Notice

Category : <u>Multi-media Projector</u>	Issued Date : <u>May / 2009</u>
Model : <u>PLC-XF35NL</u> <u>PLCXF35N</u> <u>PLC-XF35</u>	Effective from : <u>Chassis No. MY8-XF3503</u>
Destination : <u>U.S.A.,Canada,</u> <u>Europe,Asia,Africa</u>	REF. NO. : <u>SM5110413</u>
	MY8-XF35NL03 MY8-XF35N03

Service Flash :
This service flash concerns the model replaced with new LCD Panel (LCX082BLF) by service. (Chassis No. is changed to MY8-XF3503, XF35N03, XF35NL03.)

REFERENCE NO. SM5110413-07

1. Chassis No. Check

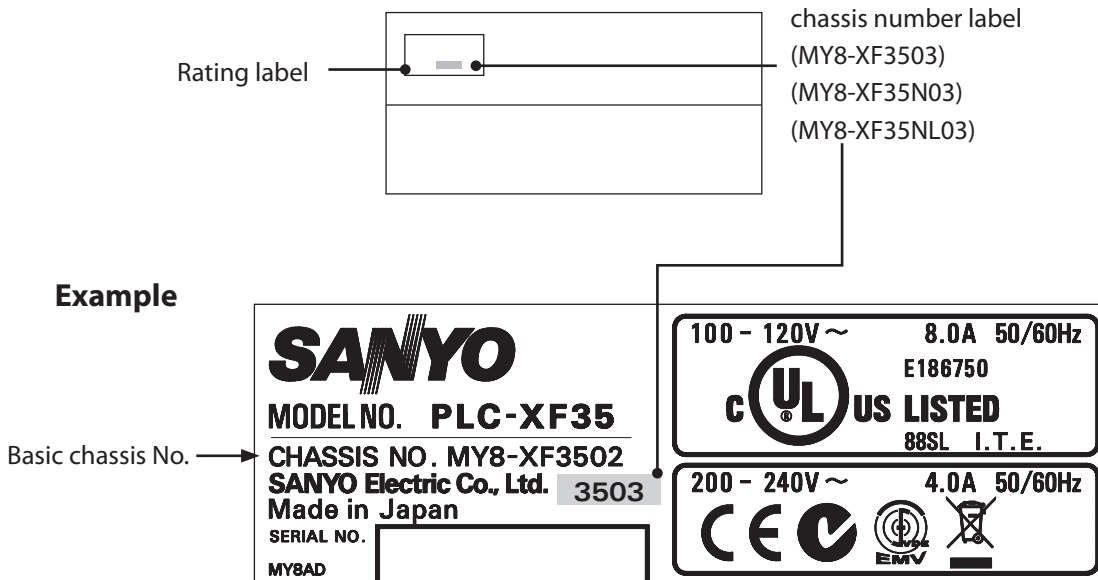
Check the printed chassis number on the Rating Label.

This service flash is effective for the chassis number "MY8-XF3503, MY8-XF35N03, MY8-XF35NL03".

Two chassis No. is displayed.

The projector in which chassis No. of **MY8-XF3503, XF35NL03, XF35N03** is not displayed is off the subject of this notice.

2. Panel Type Check

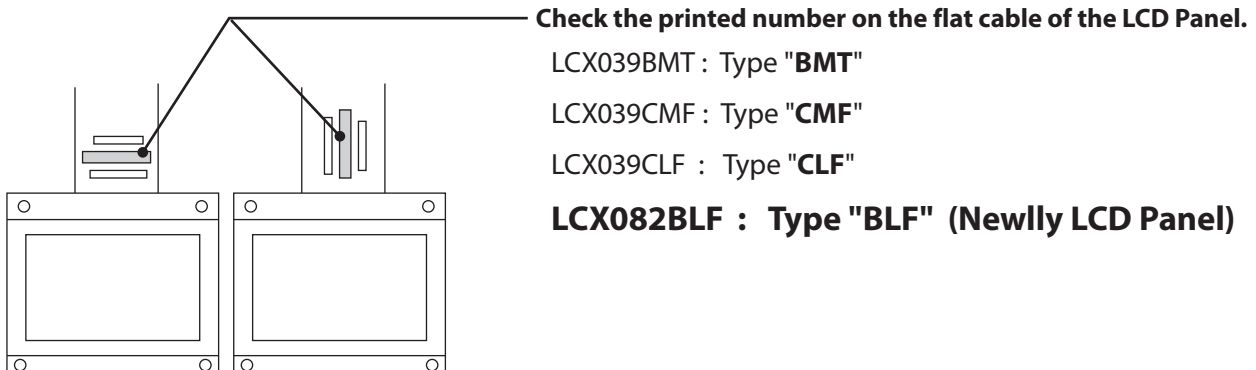
Check the printed number on the flat cable of the LCD Panel.

This service flash is effective for the type "BLF".
